UNITED STATES ENVIRONMENTAL PROTECTION AGENCY  
WASHINGTON, D.C. 20460

**WASTE CHARACTERIZATION TIER 1 CHANGE REPORT**

**EPA TIER 1 EVALUATION**  
**OF THE CENTRAL CHARACTERIZATION PROGRAM**  
**REMOTE-HANDLED TRANSURANIC WASTE CHARACTERIZATION PROGRAM**  
**FOR THE IDAHO NATIONAL LABORATORY:**  
**ADDITION OF WASTE STREAM ID-TRA-W345-RH (LOT 8B)**

**November 2014**

**Figure 1. Radiological Characterization Flow Diagram for Waste Stream ID-TRA-W345-RH**

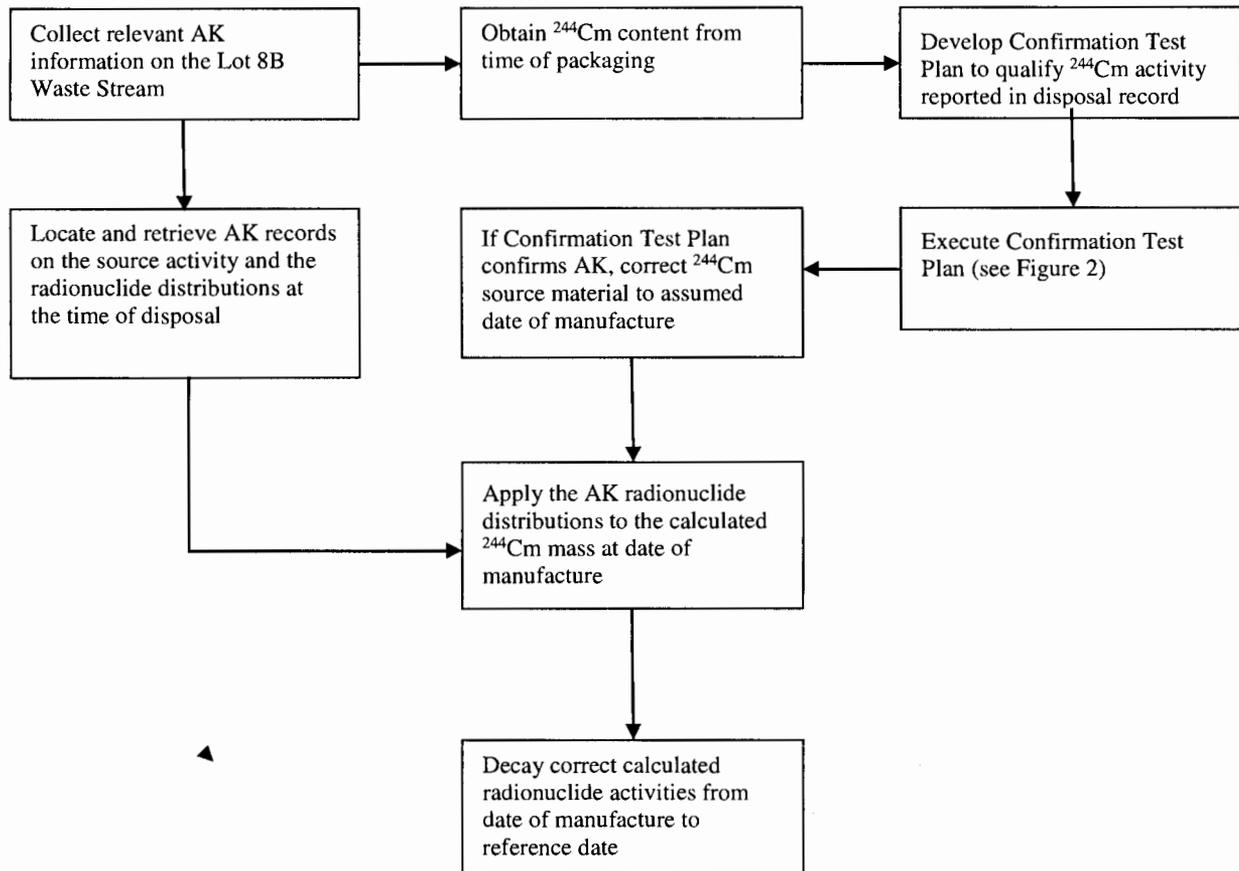
The radiological characterization process for Waste Stream ID-TRA-W345-RH uses a neutron-based DTC method to confirm the  $^{244}\text{Cm}$  content as reported in AK. EPA prepared a flow diagram to reflect this process, shown in Figure 1 below. EPA determined that the radiological characterization process for Waste Stream ID-TRA-W345-RH was technically adequate and appropriately documented. There were no concerns regarding the overall radiological characterization process and its documentation.

**Figure 2. Outline of Confirmation Test Plan**

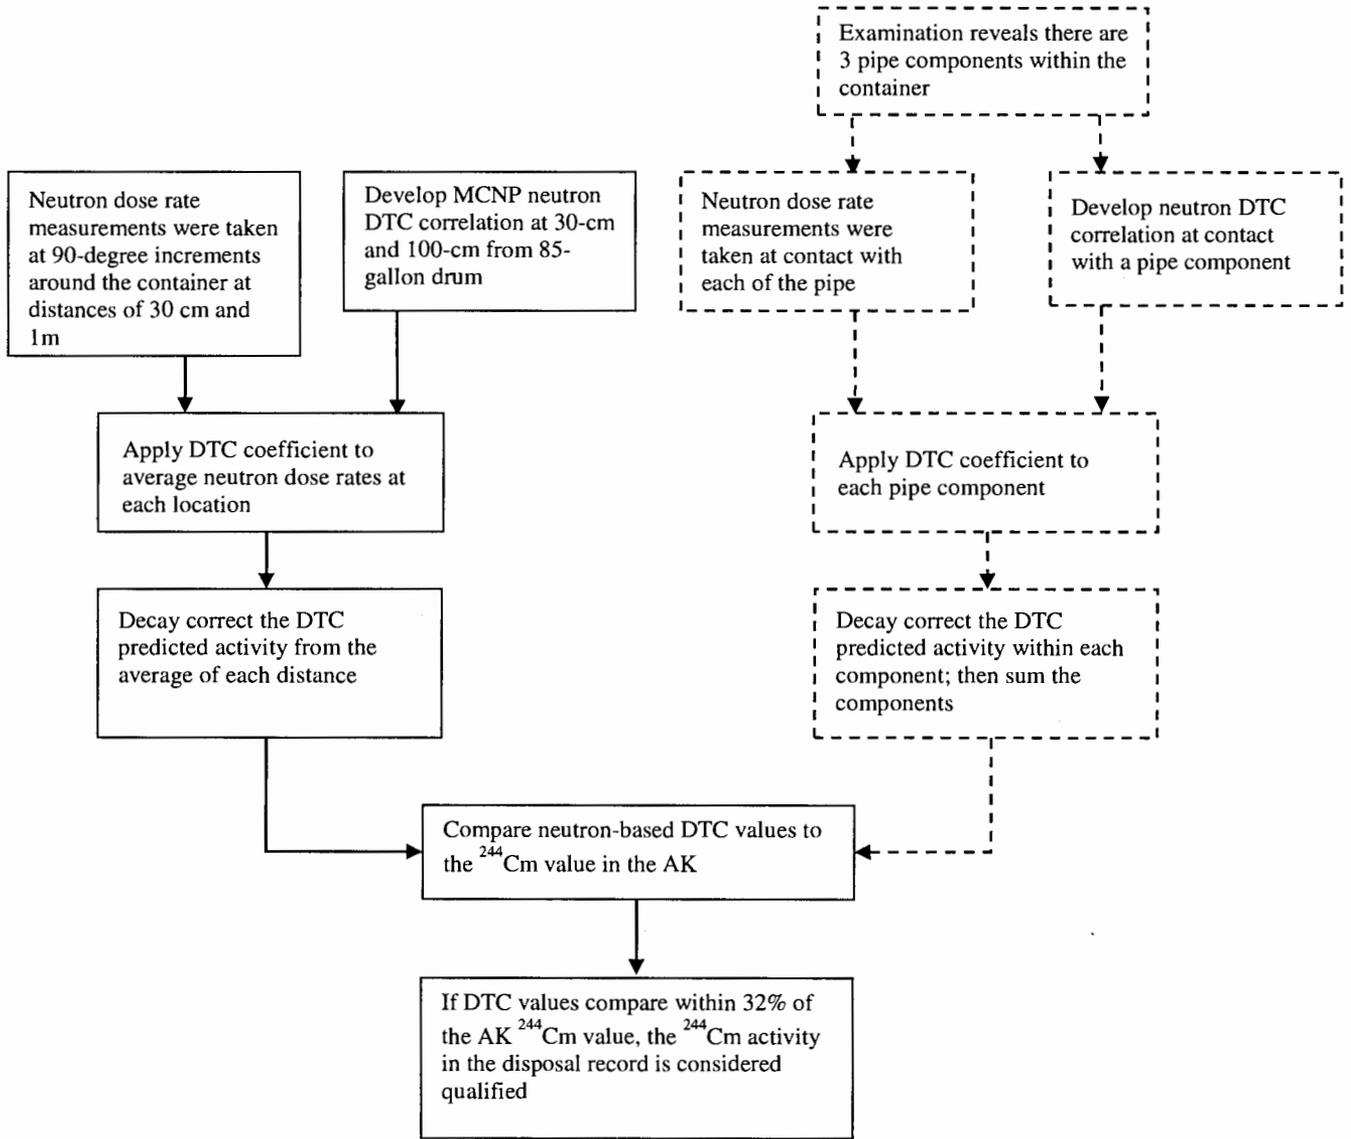
INL-CCP developed a confirmation test plan (CTP), CCP-CN-INL-635, and EPA prepared a flow diagram to reflect this process, shown in Figure 2, below. The CTP outlines a neutron-based DTC approach where neutron dose<sup>2</sup> rates are taken at distances of 1-meter (m) and 30-centimeters (cm) at 90-degree rotational increments around the drum. The averages of each set of measurements were used to determine the drum's  $^{244}\text{Cm}$  content. The DTC approach is discussed in additional detail in Item (3), below.

Although not part of the CTP, INL-CCP determined that there were three capped pipe components within the six-inch diameter steel pipe. INL-CCP unpacked the three capped pipe components and took contact dose measurements on each. Using MCNP5, INL-CCP estimated the  $^{244}\text{Cm}$  content of each component, the values were decay corrected<sup>3</sup> and summed for comparison to the drum loading and DTC records. These steps are shown in Figure 2 as dashed lines because they were not included in the original testing plan.

The CTP specifies that the DTC-derived  $^{244}\text{Cm}$  content would be corrected to the date of the initial drum loading, and the corrected value would be compared to the initial AK  $^{244}\text{Cm}$  value of 1,112 Ci. The CTP states that the comparison would be acceptable if the two values compared within 32%. This criterion is based on: a measurement uncertainty of 25%; an MCNP5 modeling uncertainty of 10%; a source date uncertainty of 10%; and, a concrete composition uncertainty of 15%. These values were combined in quadrature<sup>4</sup> to derive the acceptance criterion of 32%.

The three decay-corrected DTC-derived measurements were 1,045 Ci at 30 cm, 1,240 Ci at 100 cm and 780 Ci at contact. The average of these measurements was 1,022 Ci. All four values were within 32% of the initial value of 1,112 Ci. Based on these data, INL-CCP concluded that the reported disposal record  $^{244}\text{Cm}$  content was confirmed.

EPA reviewed the CTP and calculation package INL-RH-158, which documented the details of the confirmation process and found them to be technically adequate. There were no concerns regarding the technical adequacy and documentation of the confirmatory testing for the Lot 8B drum.
